ADDENDUM NUMBER 1

SUBJECT: Addendum Number 1 to the
Bidding Documents for Clayton Road Improvements – Phase II
Federal Project STP-5532(609)

CDG Project No. 08019

The purpose of this addendum is to provide clarification and make revisions to the bid documents.

PROJECT NO. 10114
DRAWING NO. C-213

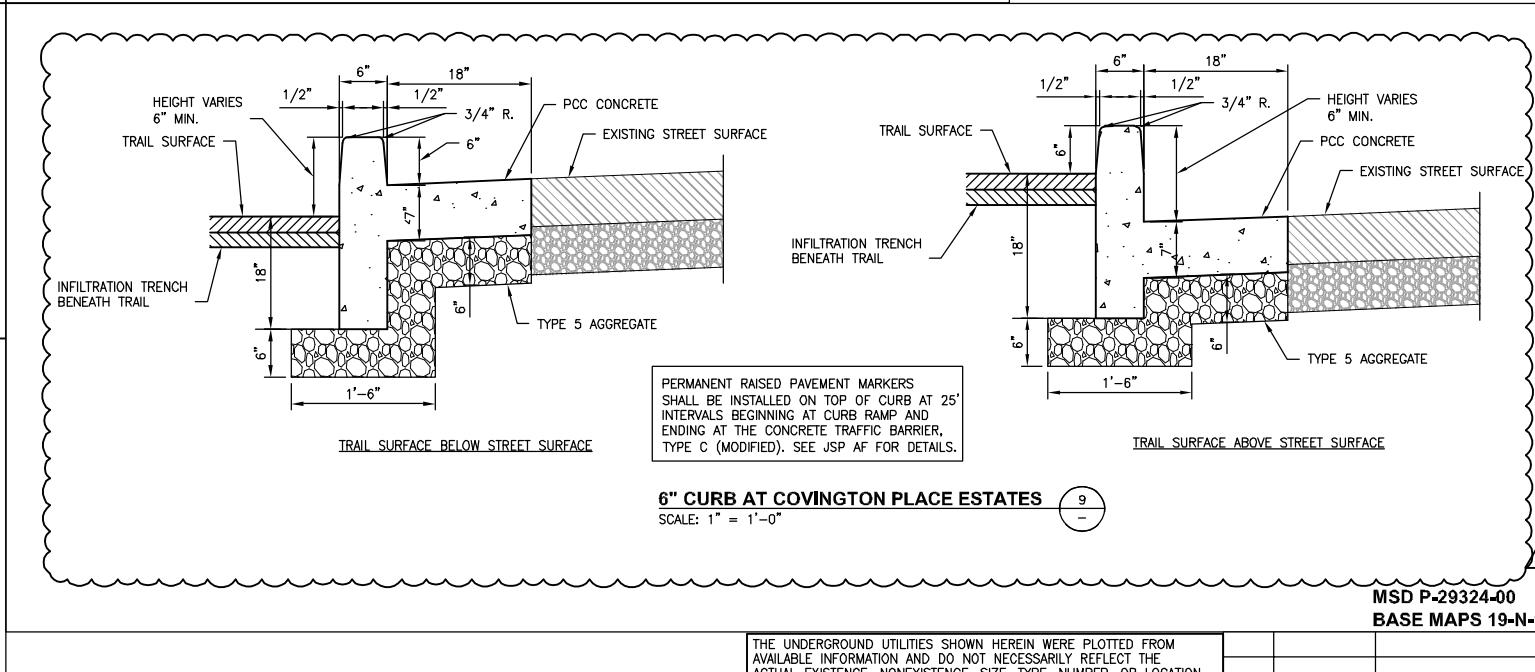
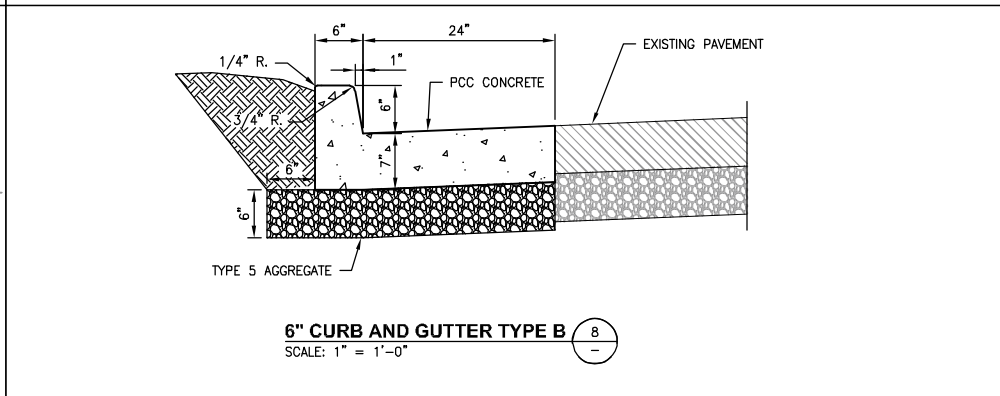
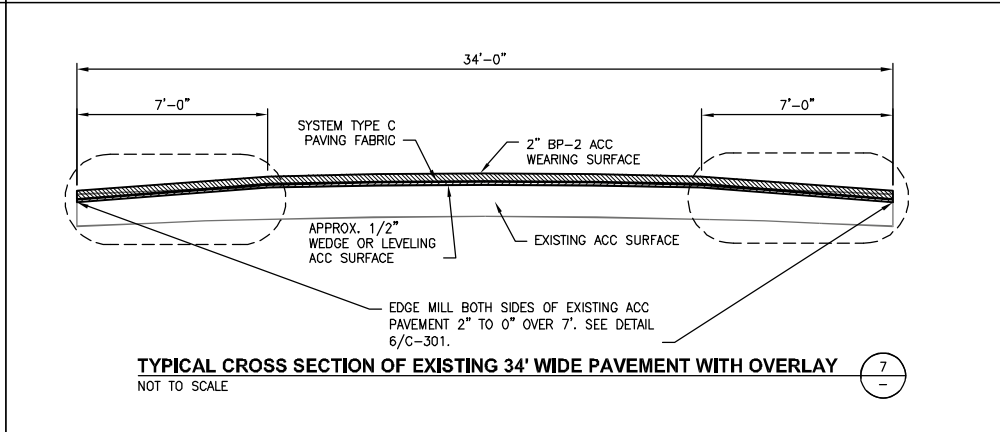
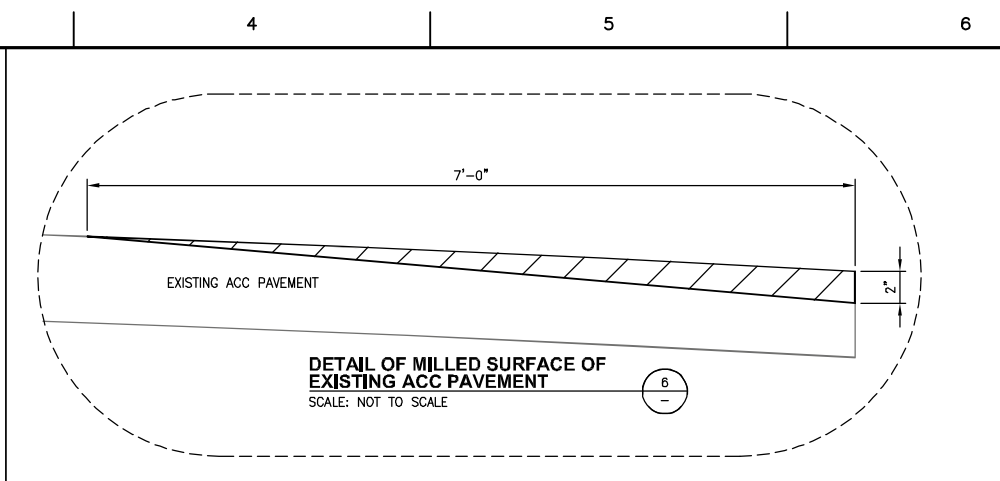
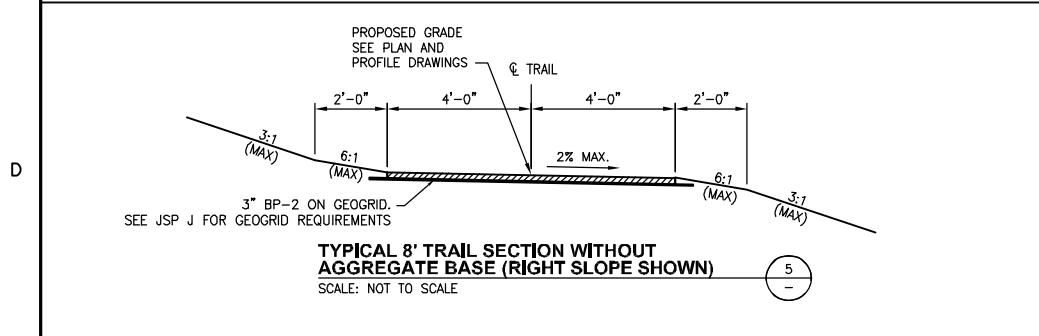
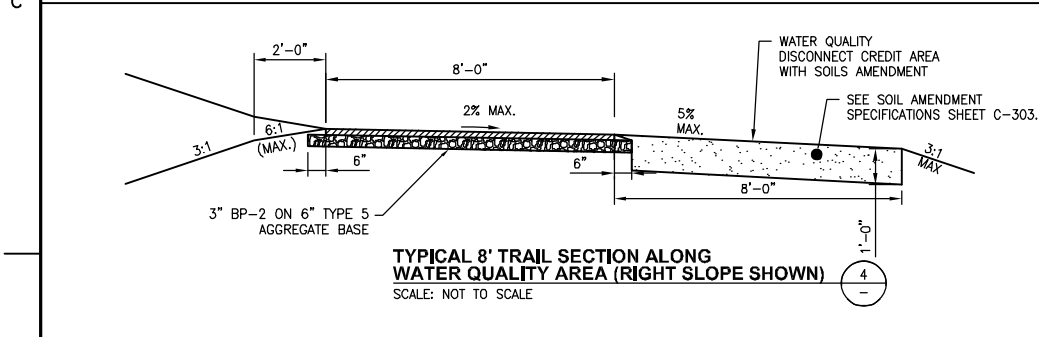
- d. C-213: Revised Cross Sections at Stations 155+50, 156+00, 157+00, and 157+50.
- e. C-301: Added 6" Curb at Covington Place Estates detail.
- f. C-303: Revised details

PROJECT NO.
10114
DRAWING NO.
C-303

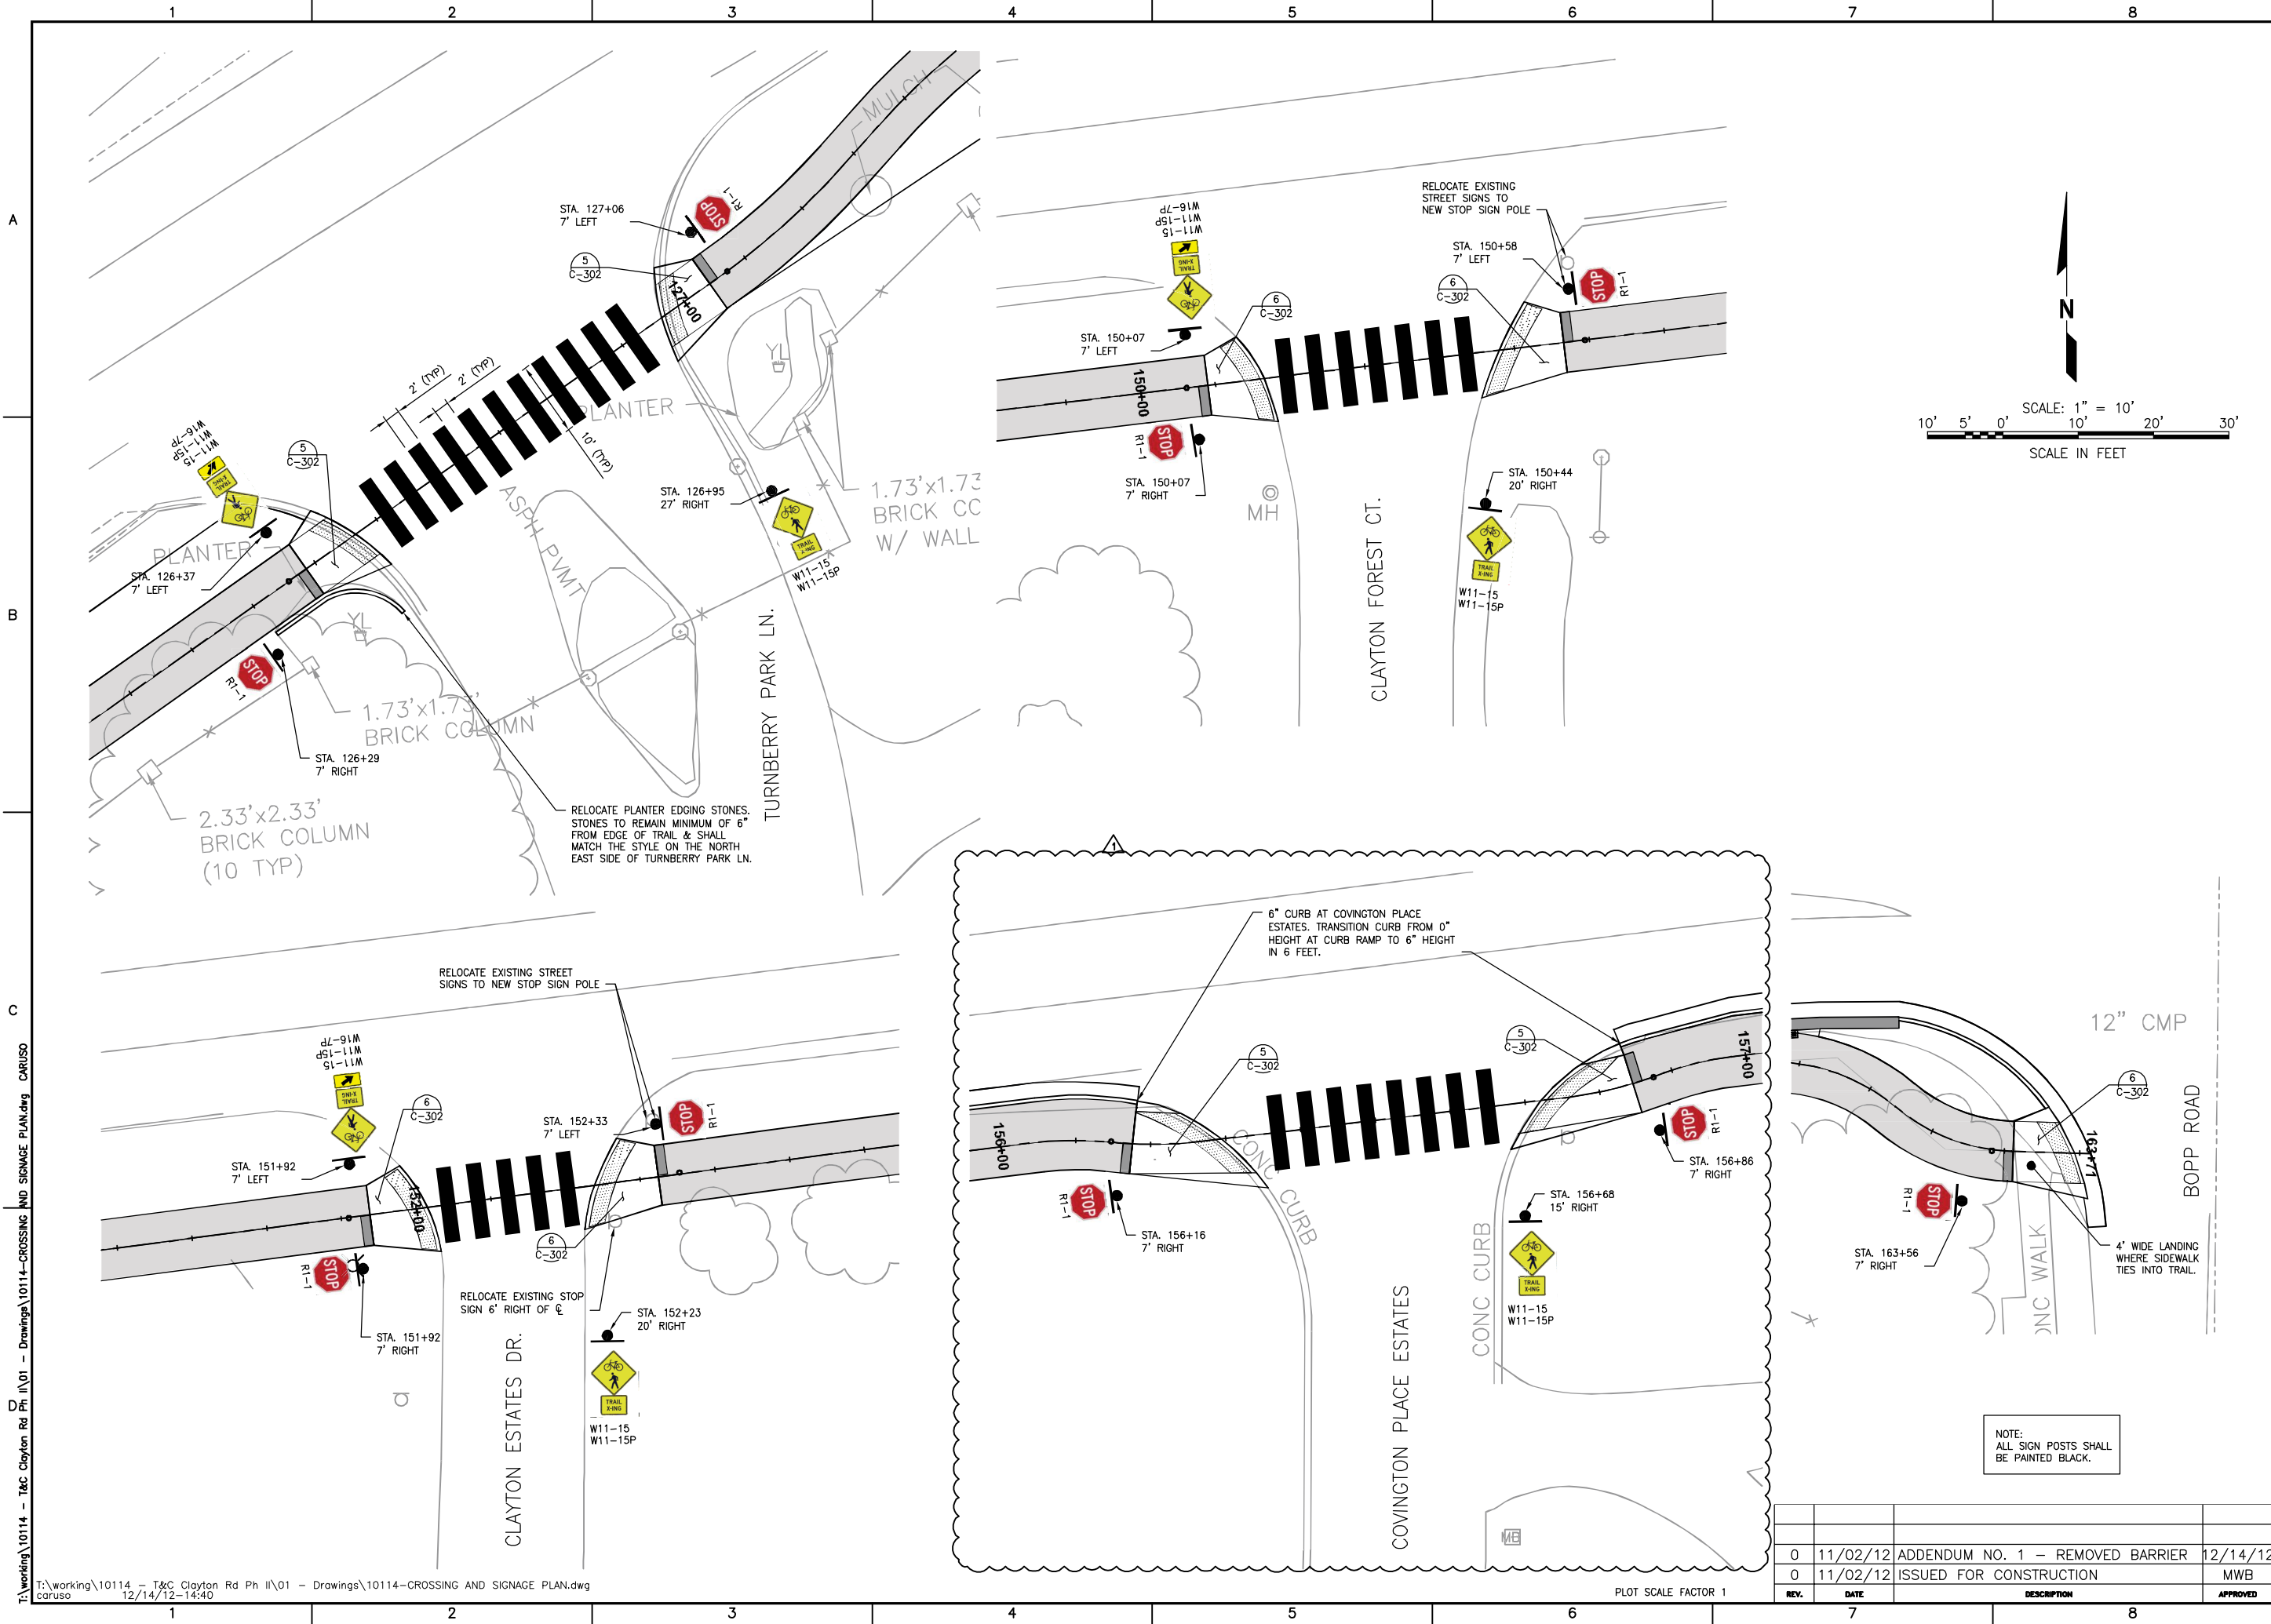
- i. Infiltration Trench Beneath Trail at Storm Structure
 - ii. Infiltration Trench Beneath Trail Section
 - iii. Concrete Traffic Barrier, Type C (Modified)

- iv. Infiltration Trench Beneath Trail Section Through Storm Structure
 - v. Infiltration Trench Beneath Trail at Trench Drain
- g. C-502: Removed a portion of the Concrete Traffic Barrier Type C (Modified) and replaced with 6" Curb at Covington Place Estates.

DRAWING NO.
ST-108

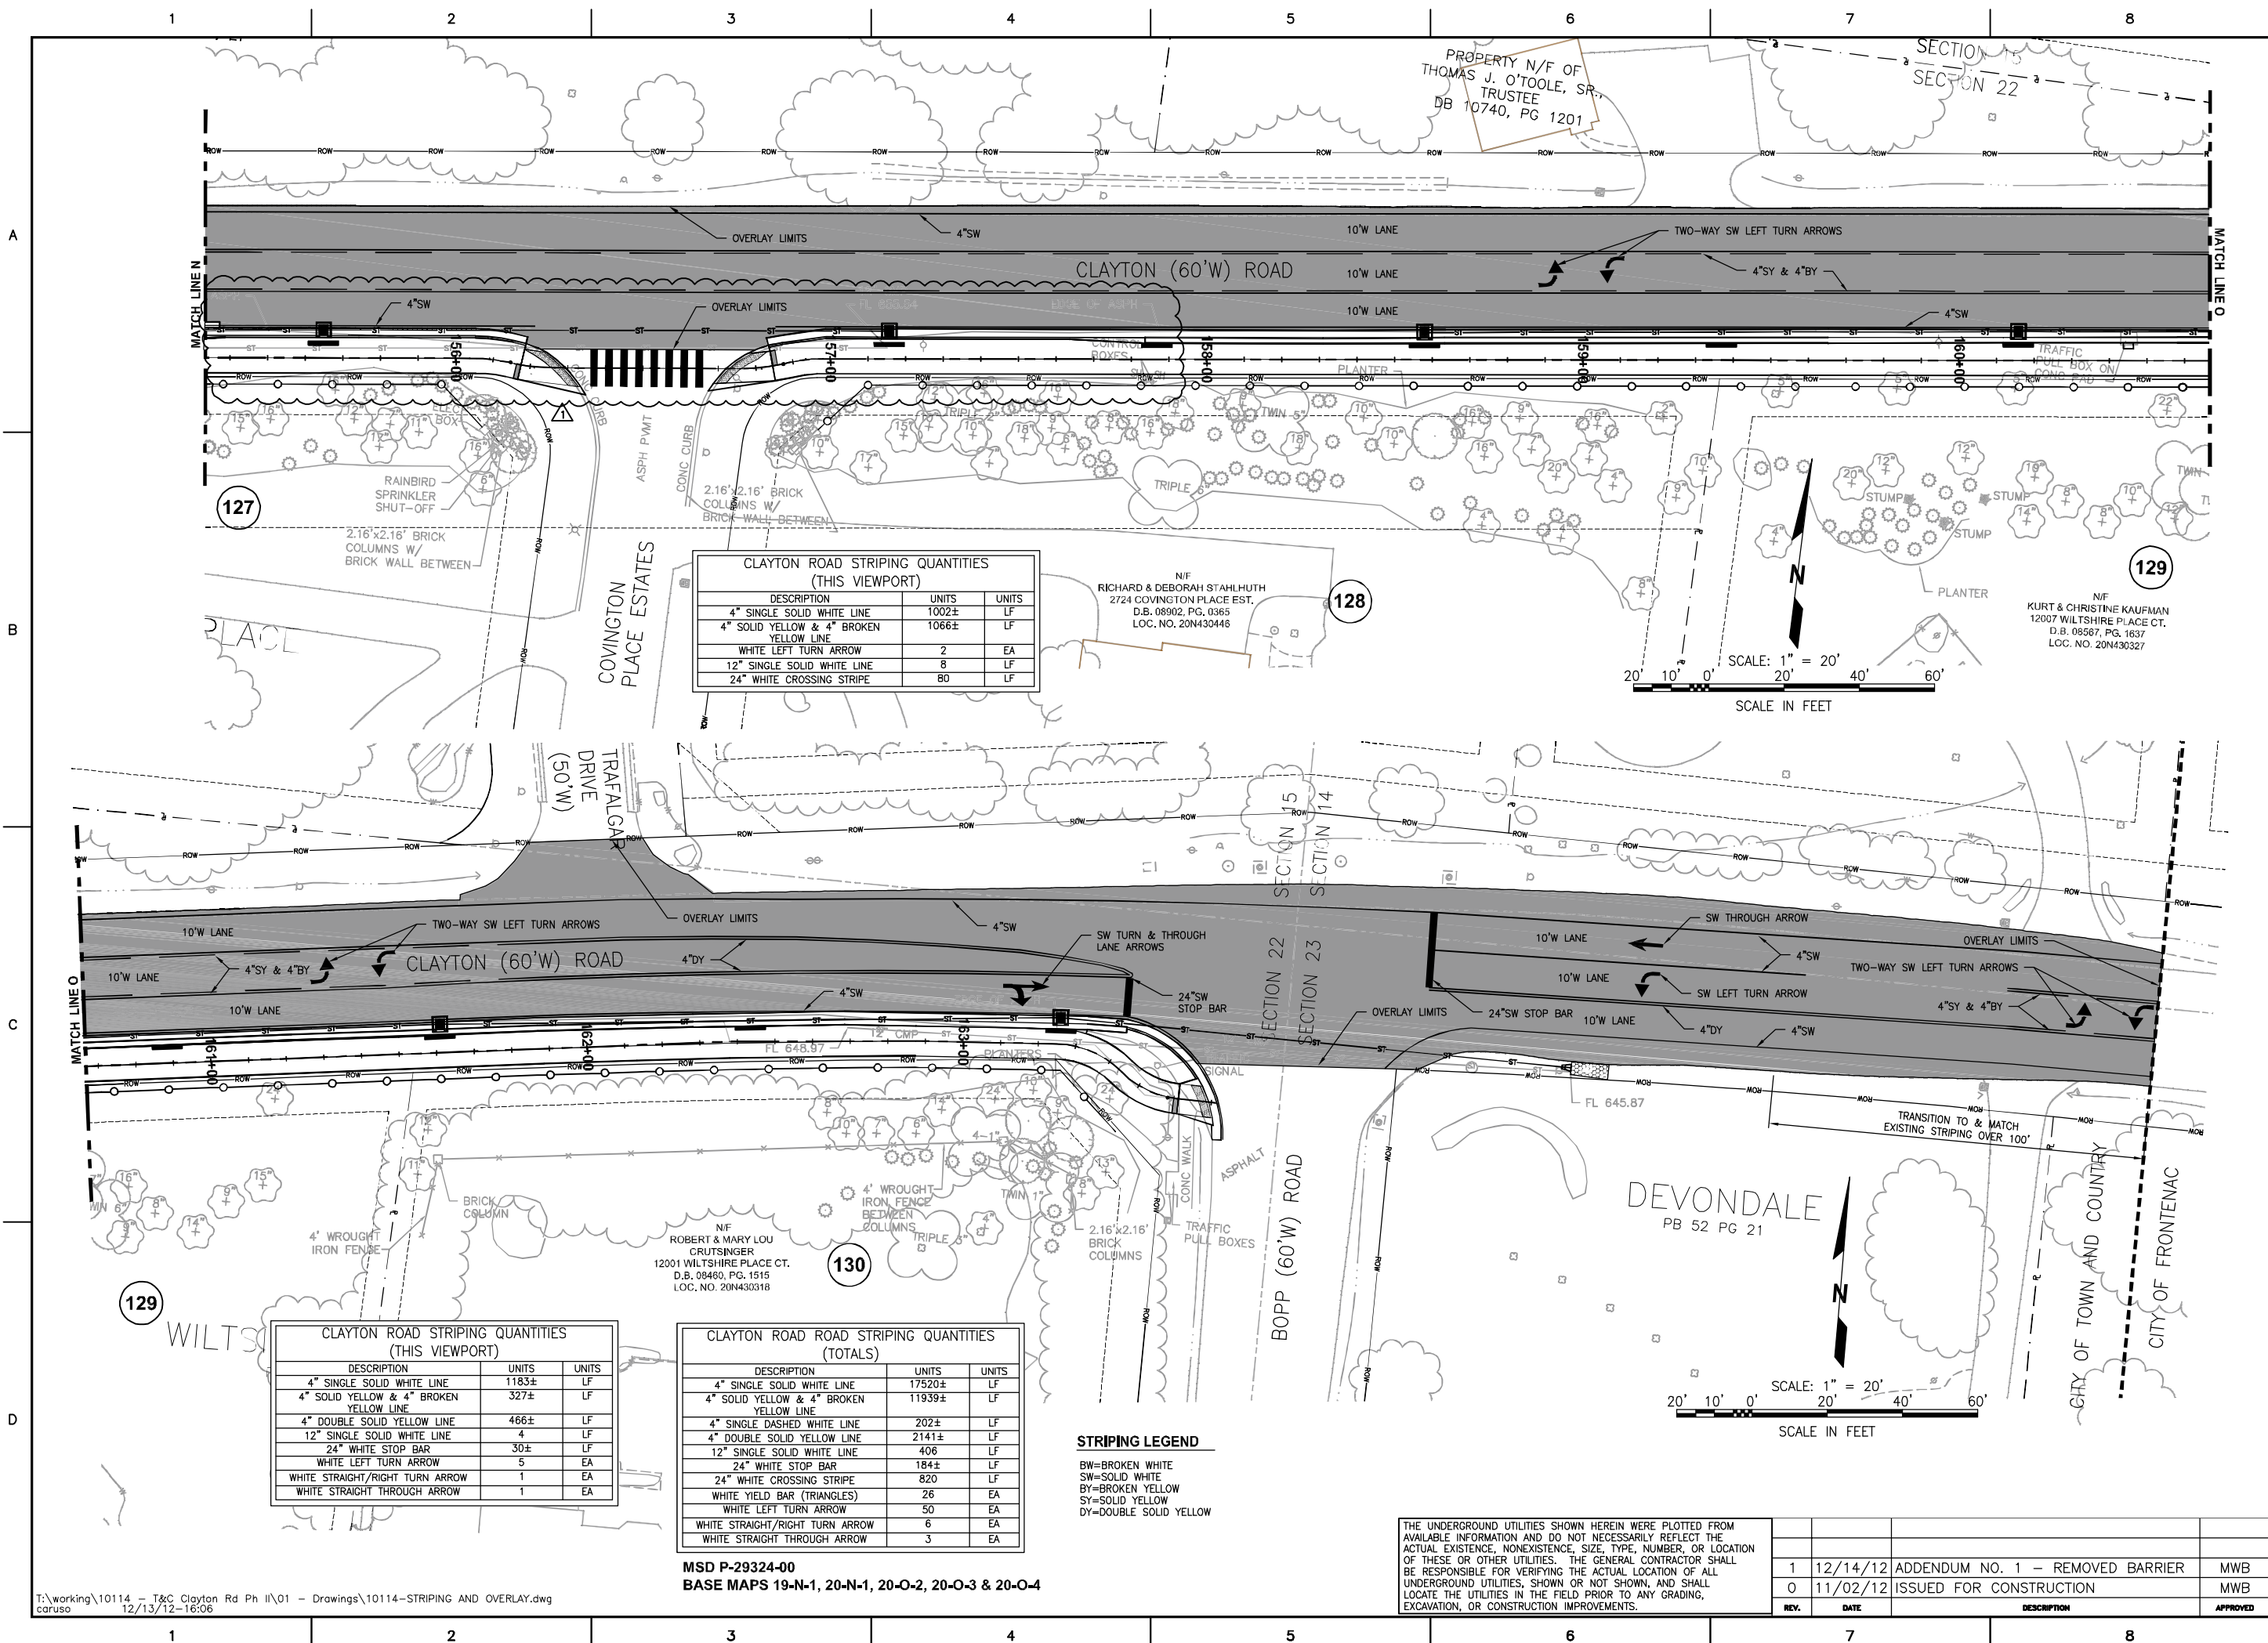
- h. ST-107 and ST-108: Removed a portion of the Concrete Traffic Barrier Type C (Modified) and replaced with 6" Curb at Covington Place Estates.
- i. R-108: Removed a portion of the Concrete Traffic Barrier Type C (Modified) and replaced with 6" Curb at Covington Place Estates.
